VIOLATIONS TO BE FIXED

220 31 STREET

NOTICE OF VIOLATION. BVC19000436220 31 STREET.

NOTICE OF VIOLATION BVC19000449. 220-224 31st St.

TYPICAL 2ND & 3RD FLOOR PLAN

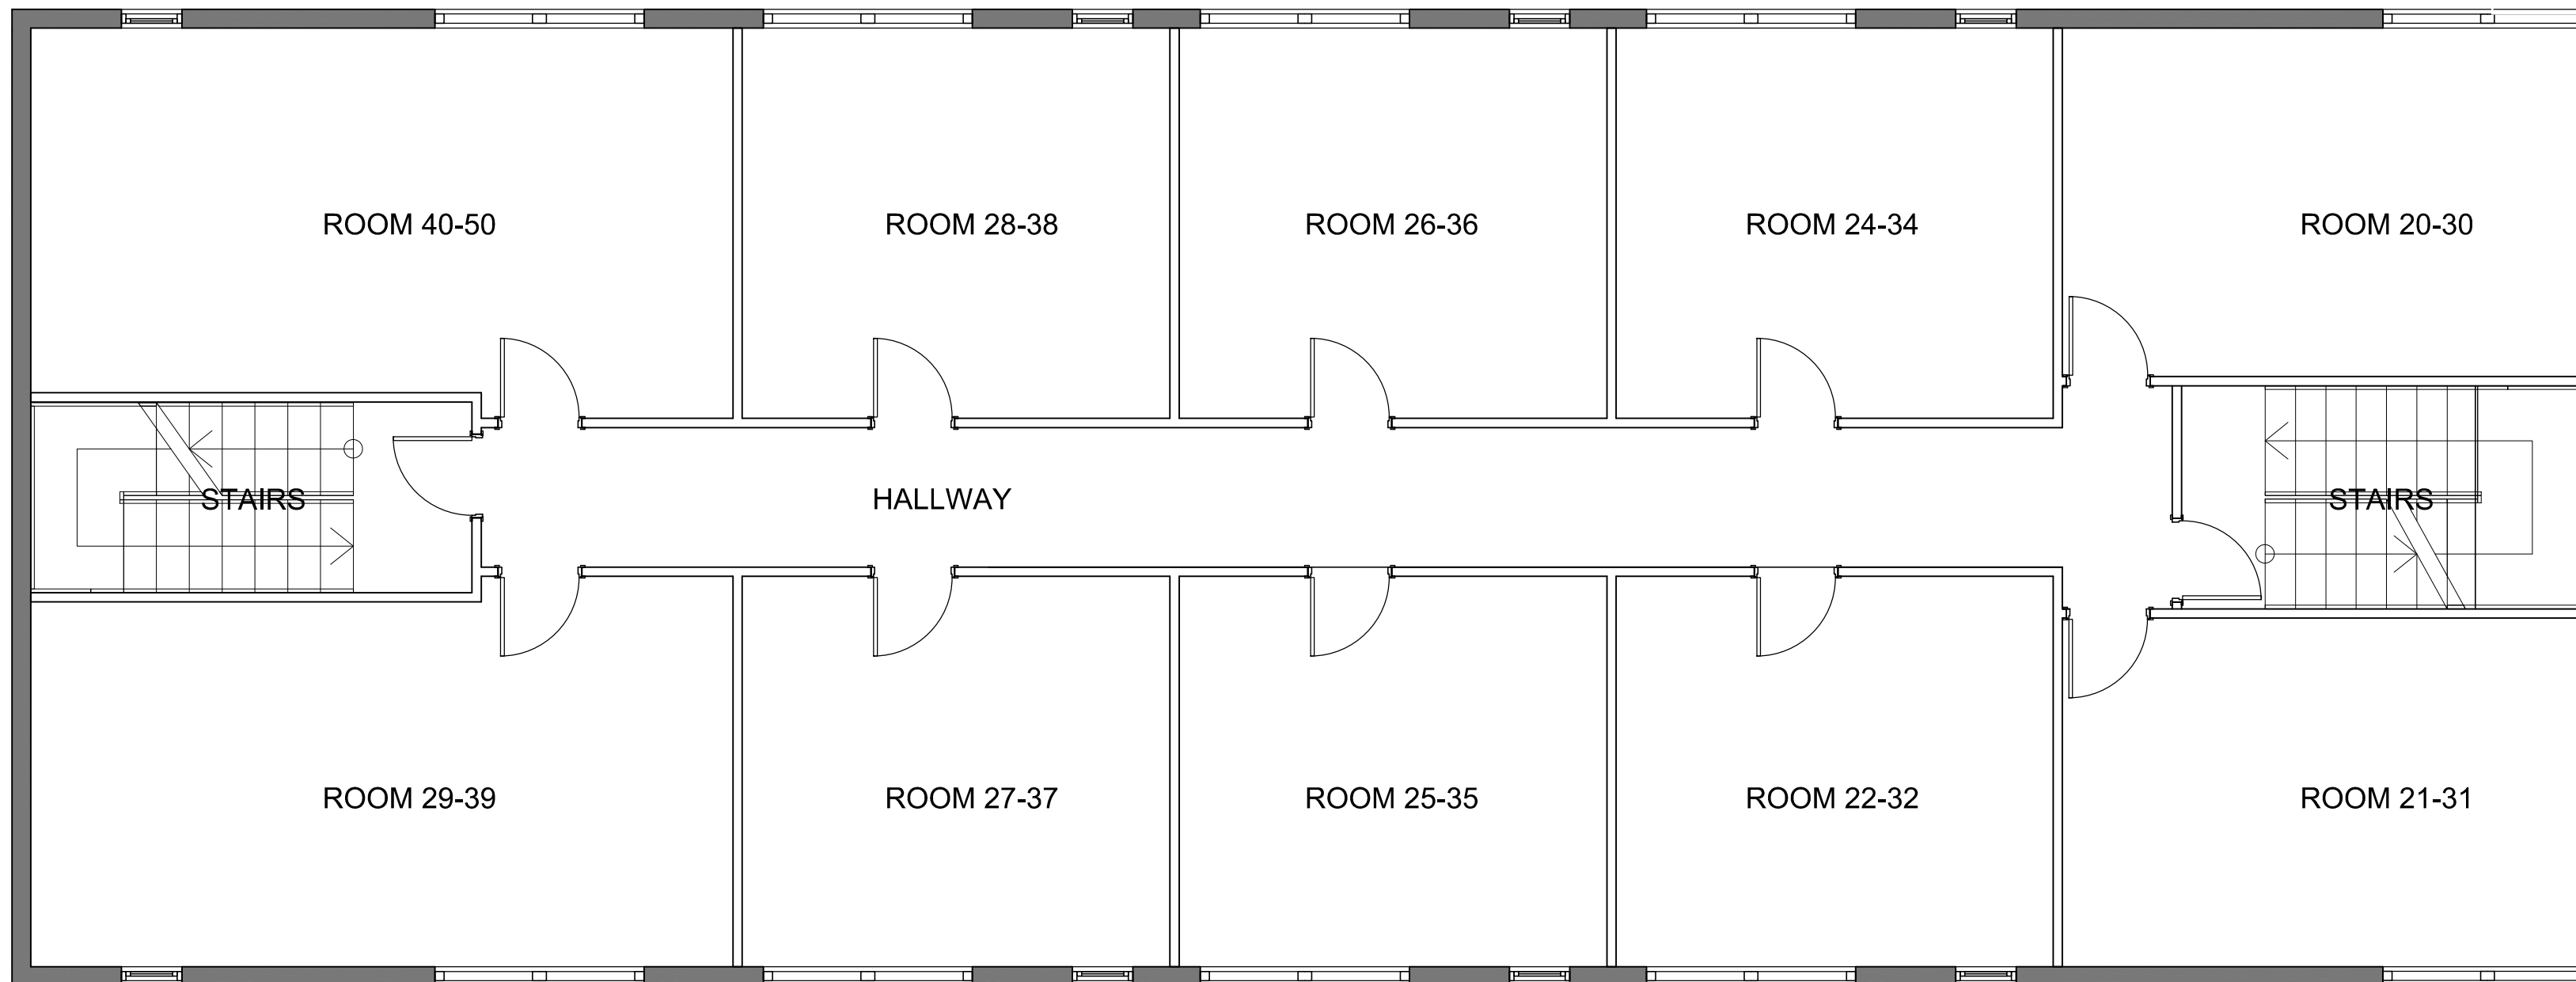
-Notice of Violation is in reference to the installation of a wooden roof structure at the rear of the property.
WOODEN ROOF STRUCTURE TO BE DEMOLISHED

-Also, for the renovation of the bathroom in unit A14.
BATHROOM IN UNIT 14 WAS SERVICED MAINTENANCE AS REQUIRED FOR CODE ENFORCEMENT.

-Boiler room with evidence of work done without approved permit and in violation of the Florida Building Code, safety conditions are compromised.
BOILER ROOM TO BE DEMOLISHED

-Work done without approved permit, plumbing and electrical installations, wood fence and gate, laundry room without permit and inspections, also evidence spalling concrete and stucco work done. Flooding conditions at basement, temporary electrical installation needs to be removed
LAUNDRY ROOM TO BE DEMOLISHED
TEMPORARY ELECTRICAL INSTALLATION TO BE REMOVED
BASEMENT HAS BEEN CLEANED AND DRY AND BACK TO ORIGINAL CONSTRUCTION

GROUND FLOOR PLAN

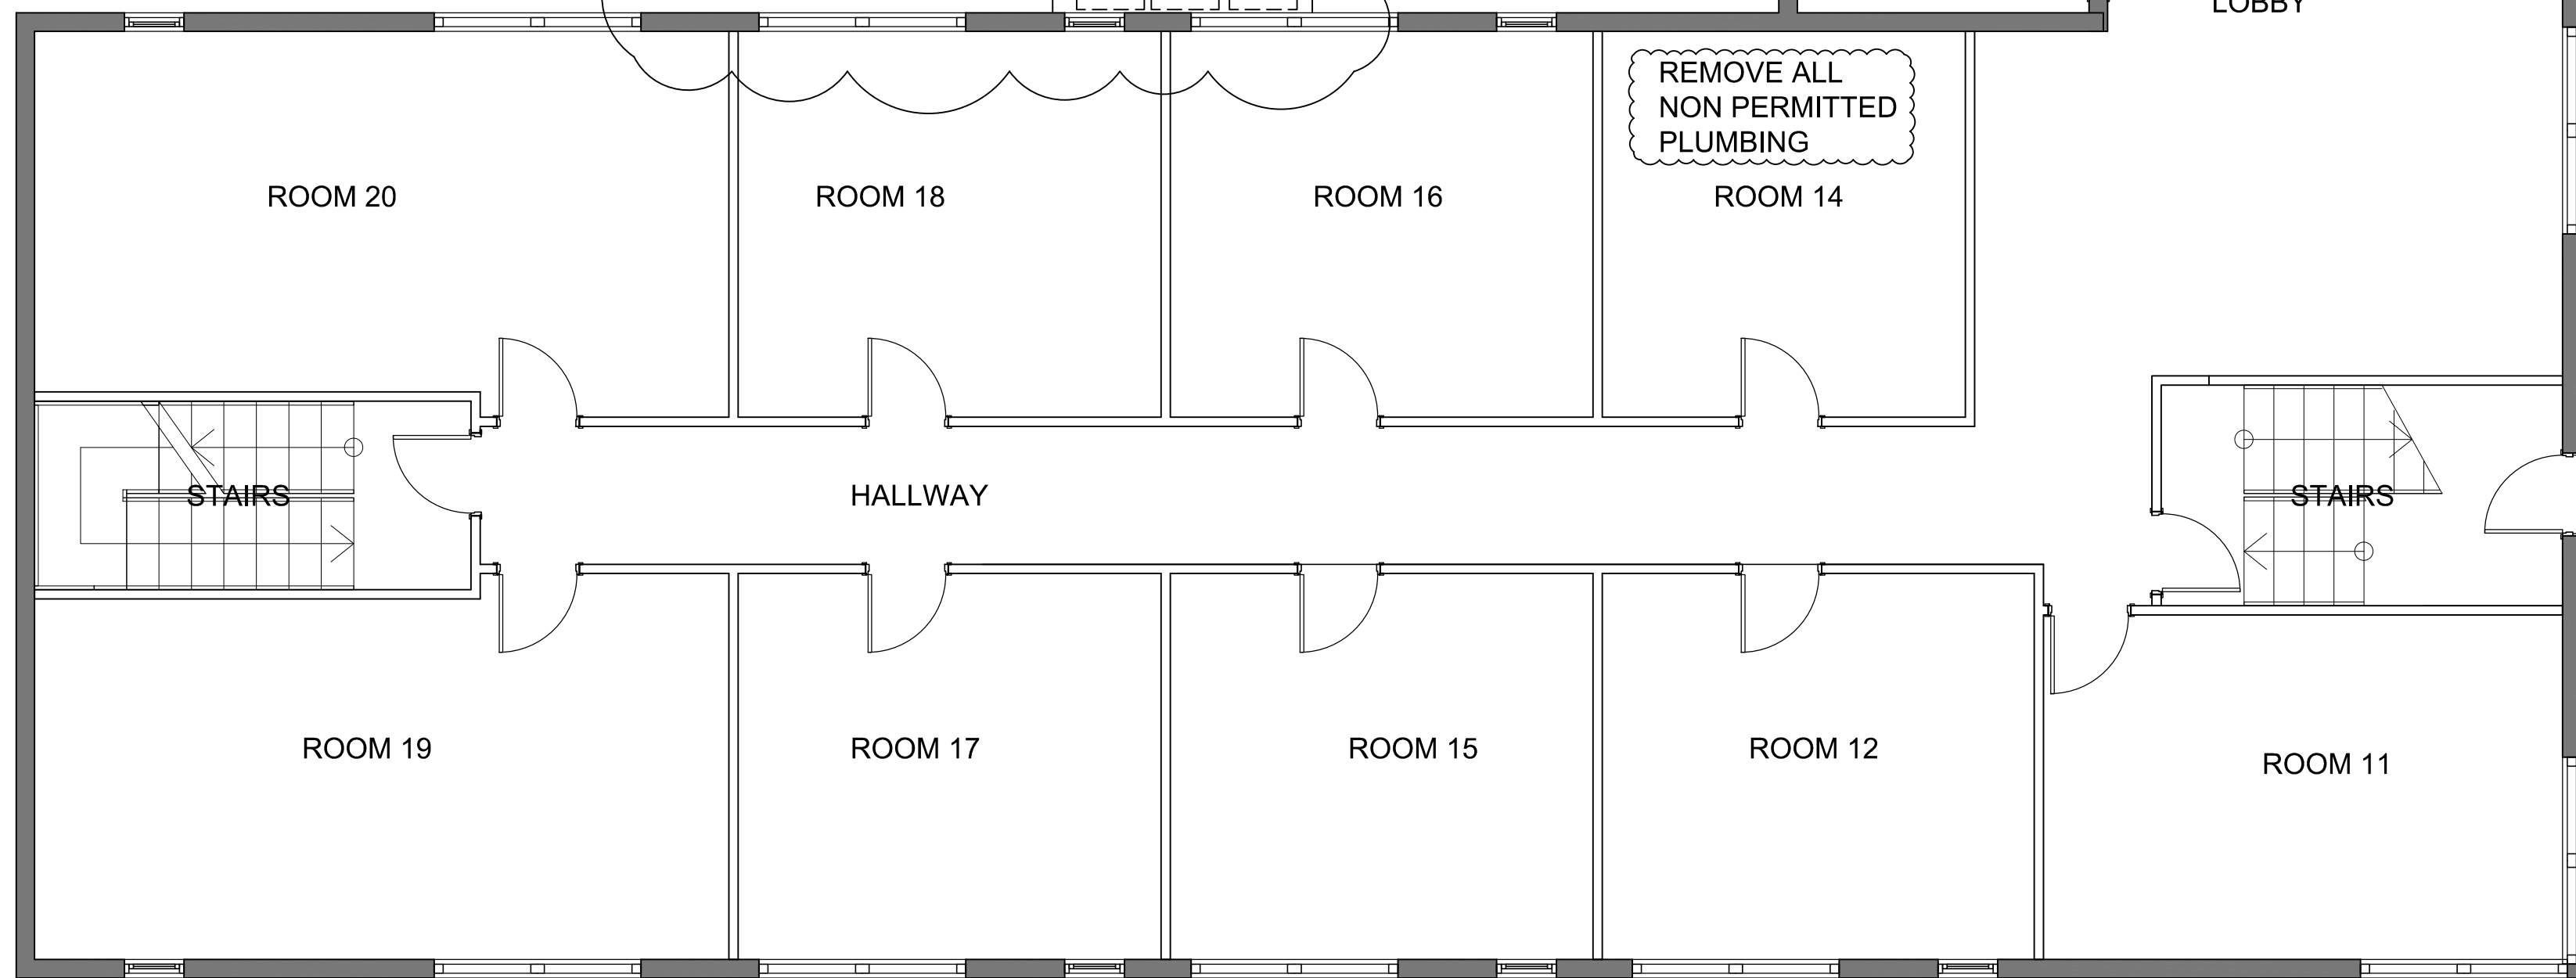
CANOPY, WASHERS &
DRYER TO BE REMOVED
LEAVING SAFETY
INSTALLATION WITH
PROPER END CAP

RAILING TO BE
DEMOLISHED
AND REPLACED
ACCORDING PLAN S-1

RAILING TO BE
DEMOLISHED
AND REPLACED
ACCORDING PLAN S-1

REMOVE ALL
NON PERMITTED
PLUMBING

GROUND FLOOR PLAN
SCALE:3/16"=1'

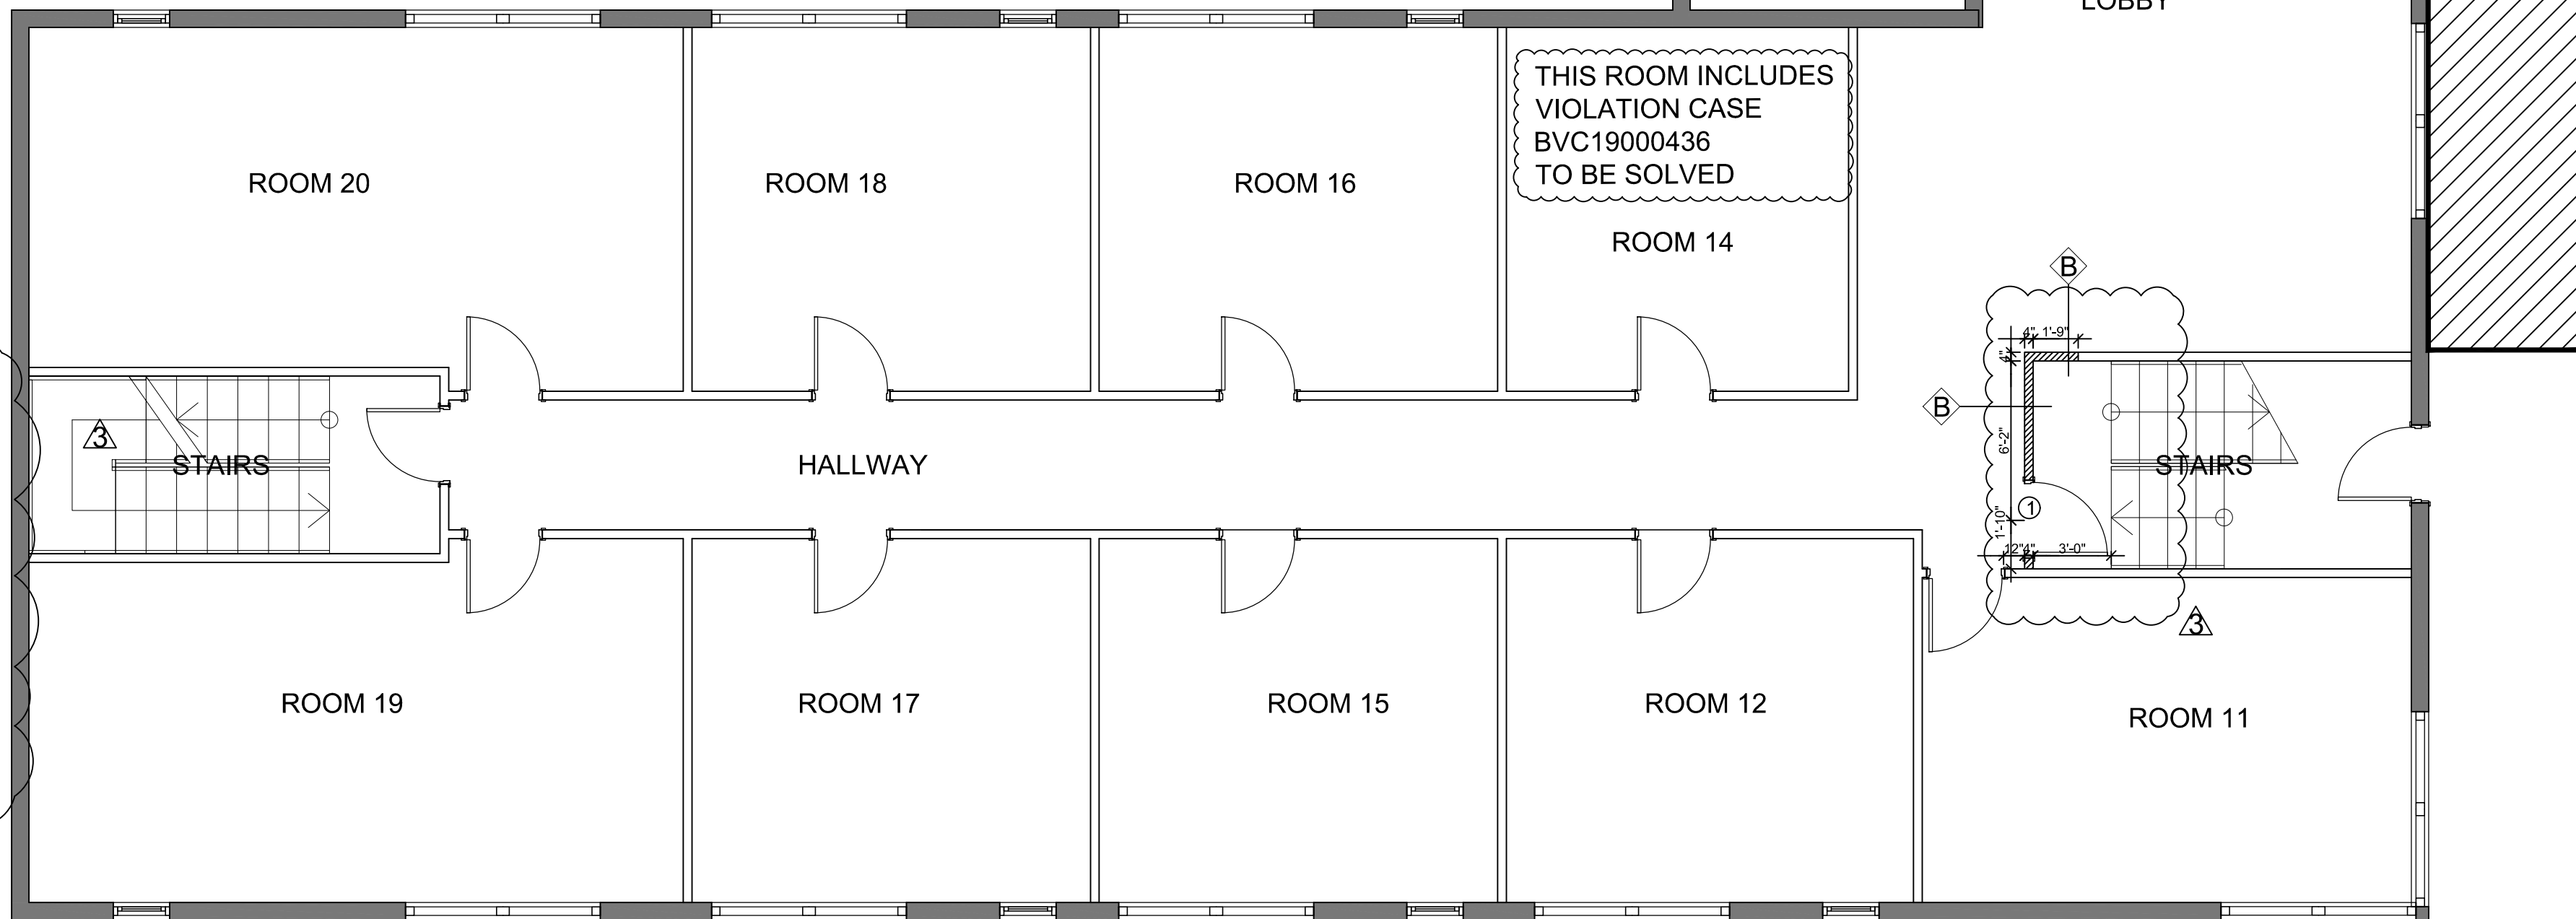
PLANNING REVIEW
Revision horizontal railing to incorporate 6
inch opening above 36' A.F.F.
R/. RAILING TO BE UP-DATED AS SHOWN
ON SHEET S-1 RAILING 42" A.F.F WITH
MAX 4" REJECT.

ROOM 20 UNDERNEATH
CRAWL SPACE TO BE
CLEANED AND OPENING
CLOSED WITH SECURE
METAL GRILL TO AVOID
SQUATTER RE-OCCUPANCY
SEE CMB PHOTOGRAPHS
FOR CASE BVC19000436
PAGE 14
